Addendum No.1
to
CONSTRUCTION DOCUMENTS
for

May 21, 2025
2023159.00

NCISD New District Administration Building
21330 Valley Ranch Parkway
New Caney, TX. 77357
May 20, 2025

S204A

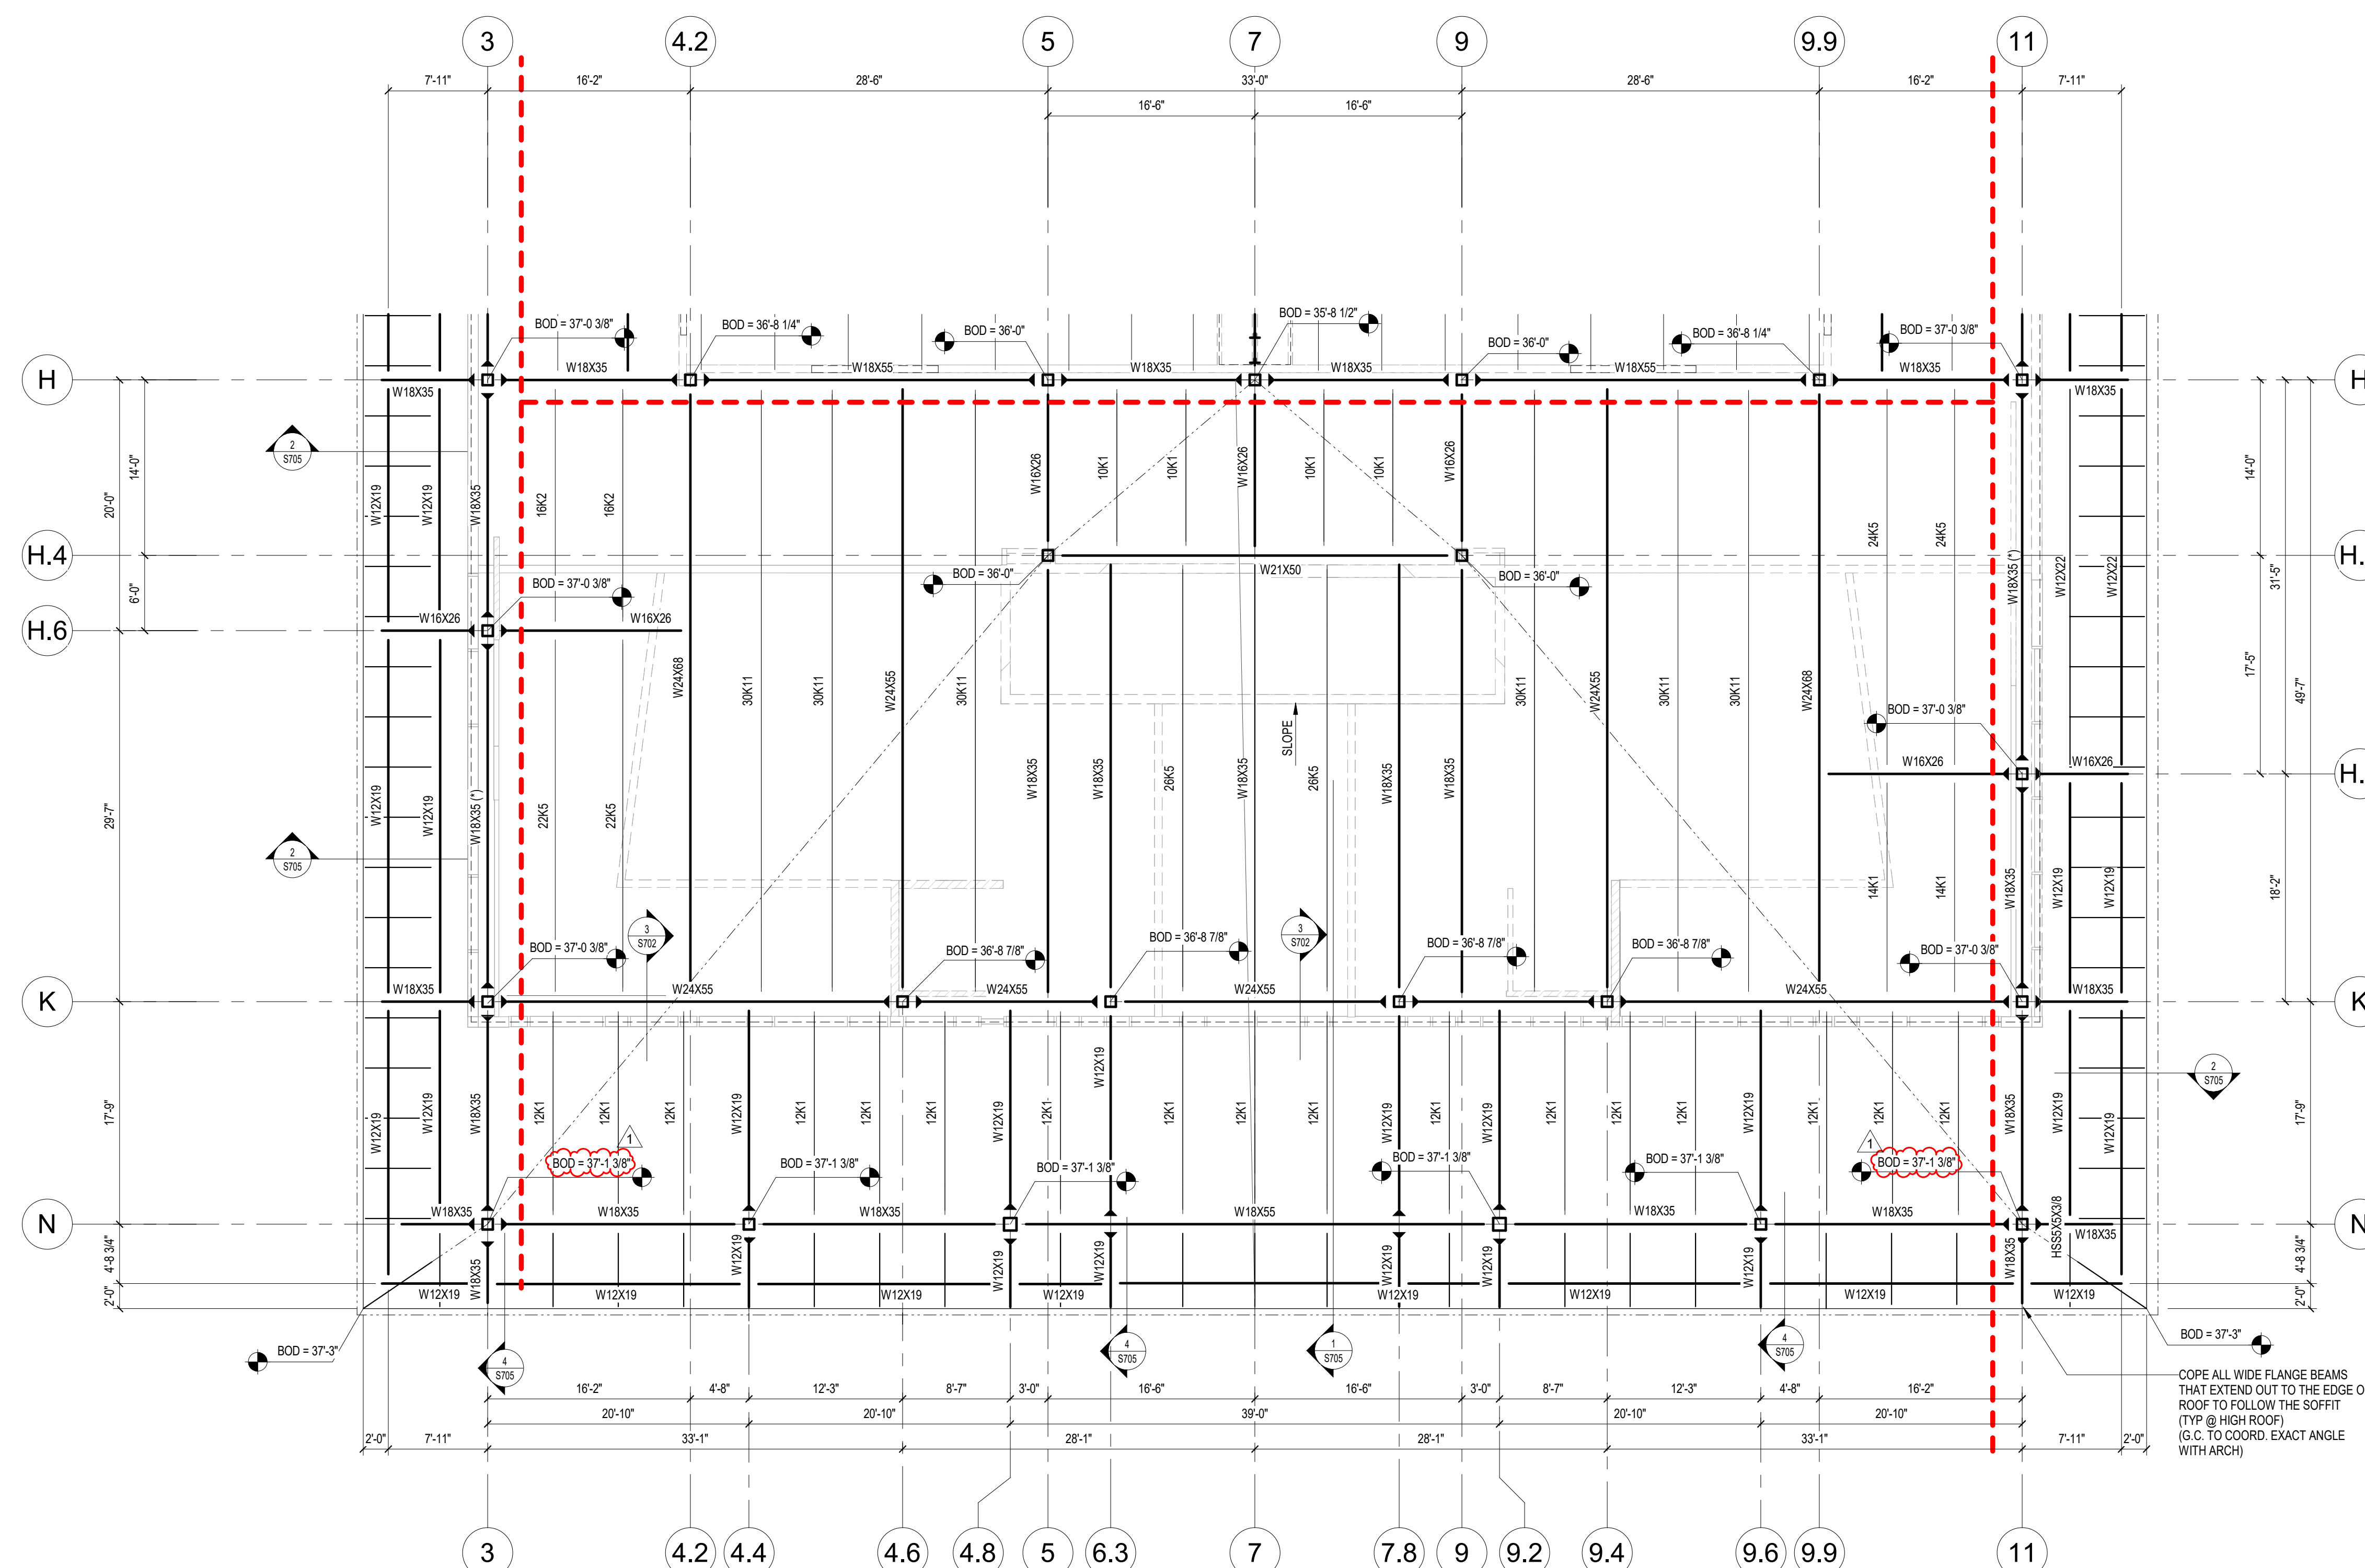
Item No. 8 Sheet S204A:

- a) Updated bottom of deck elevation.
- b) Enclosure Framing Plan added.

S204G

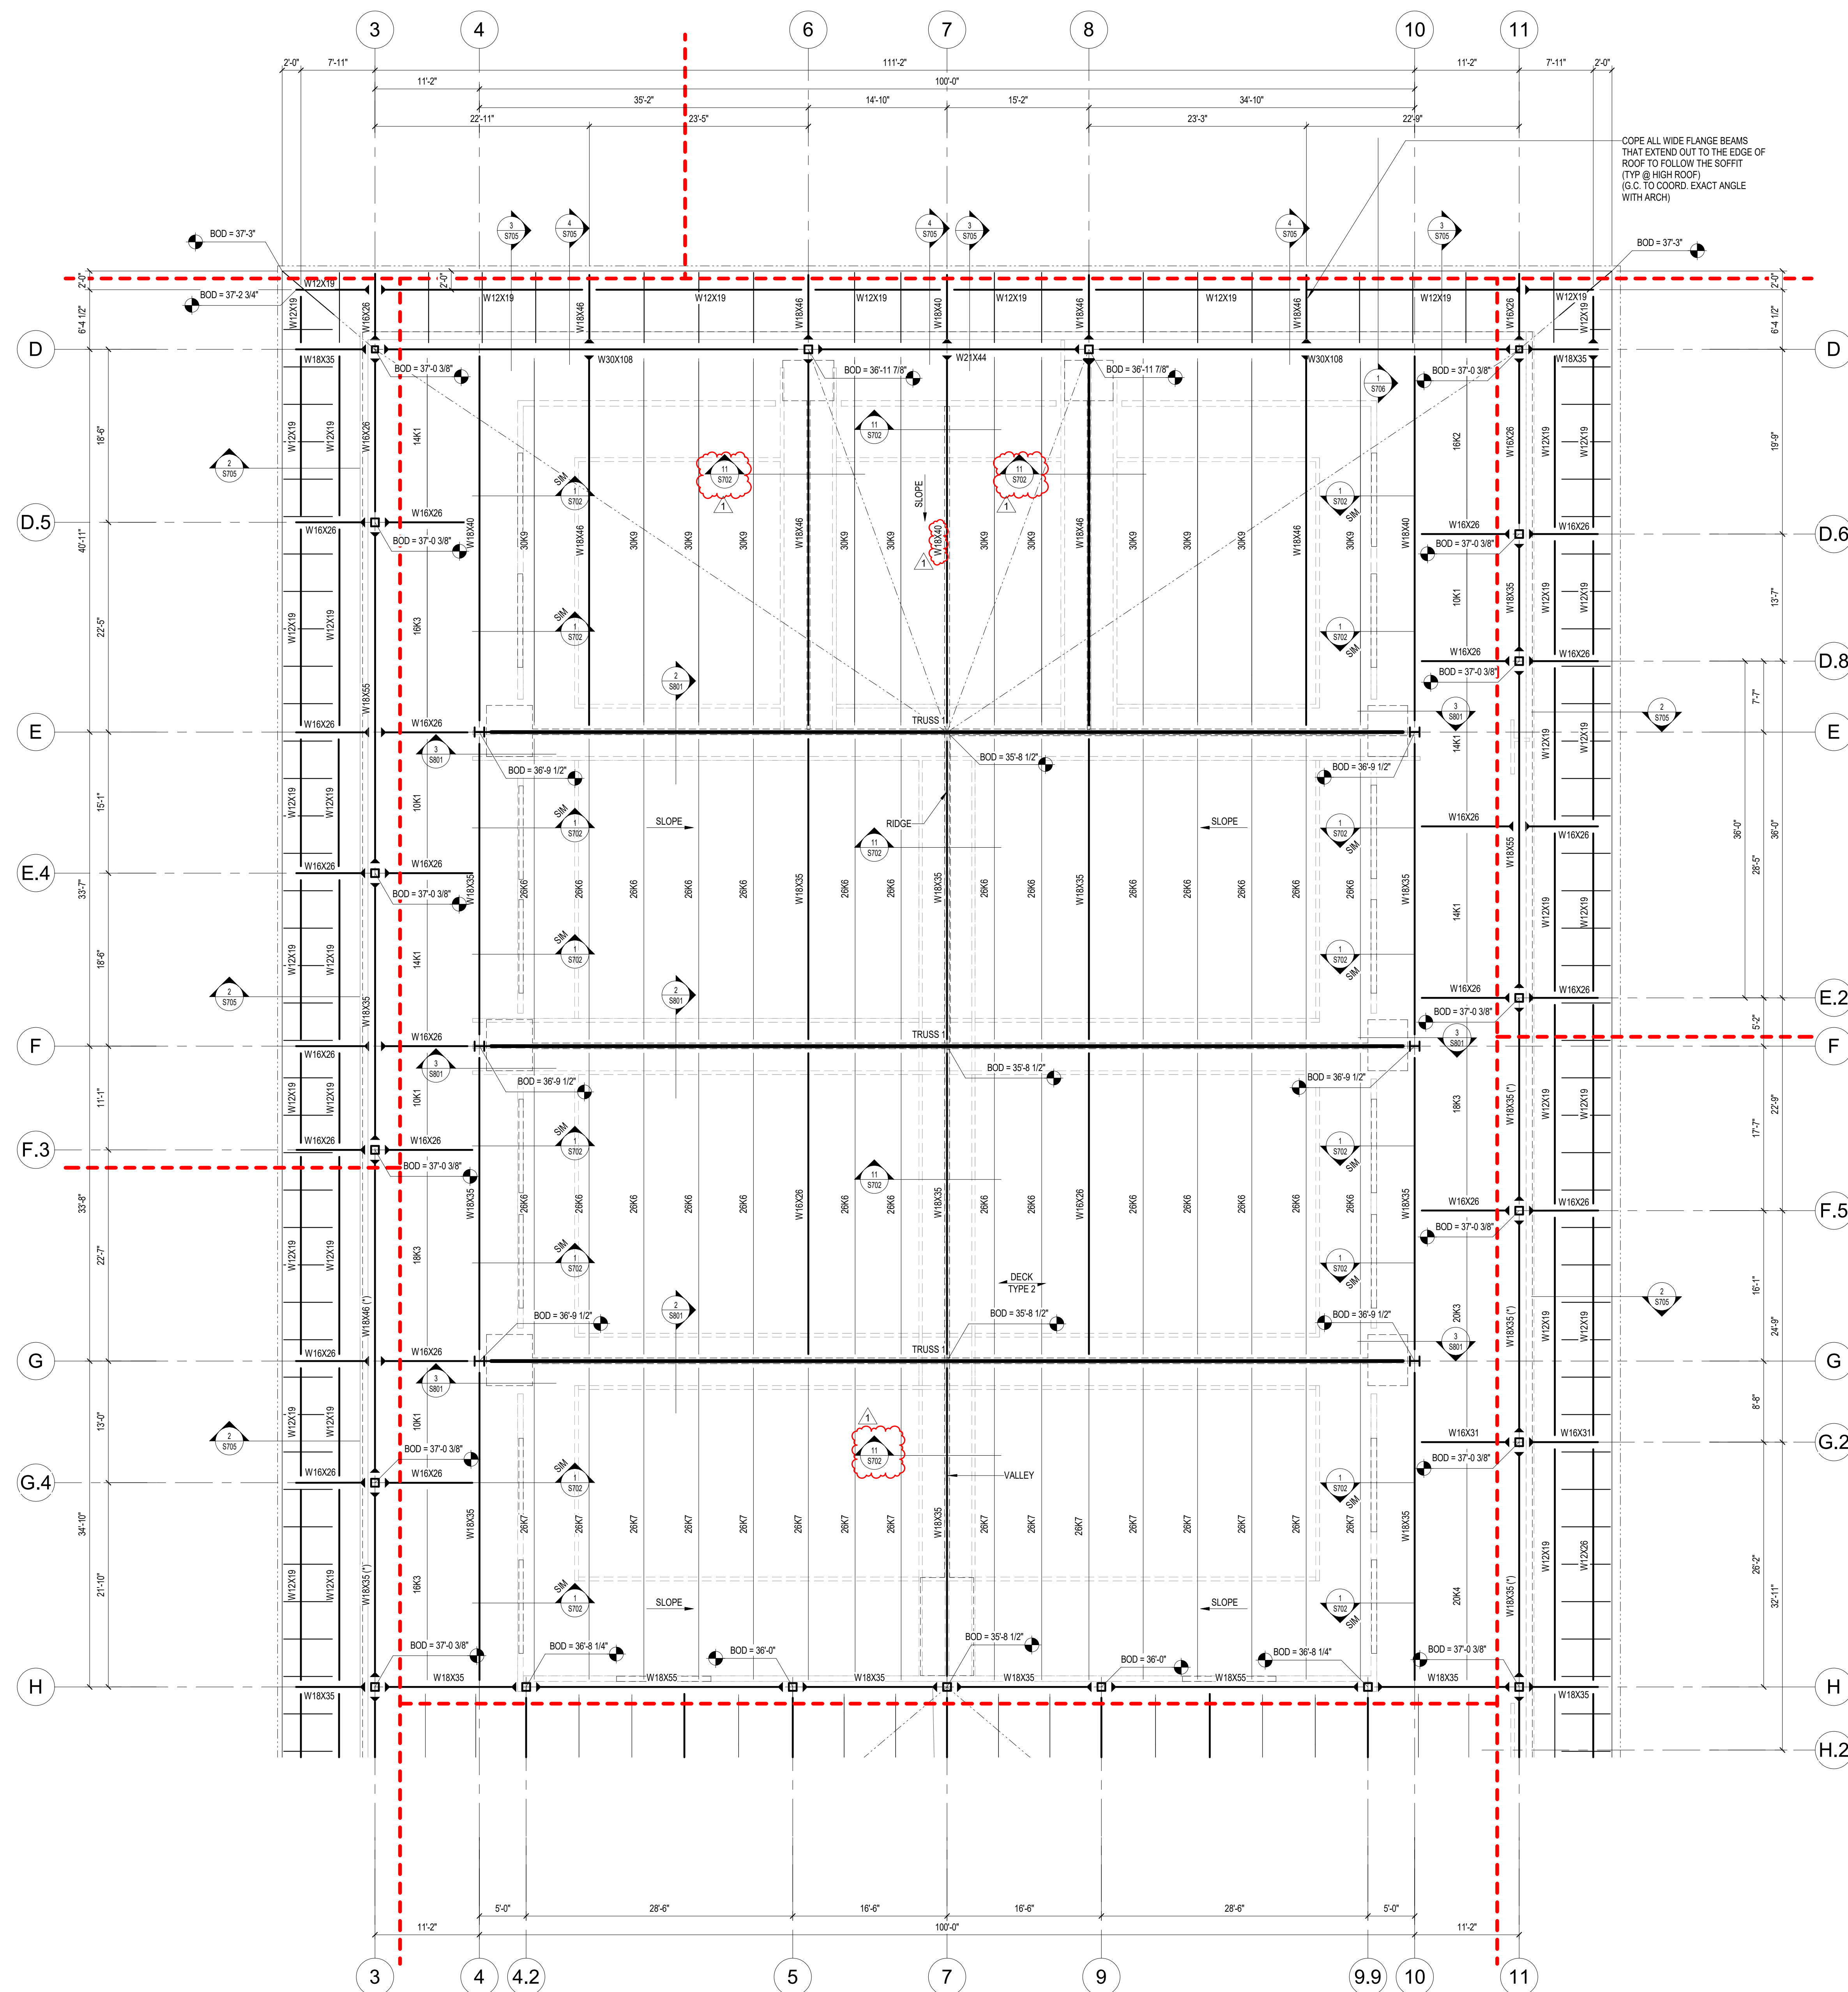
Item No. 9 Sheet S204G:

- a) Updated Beam size.
- b) Added partition section mark
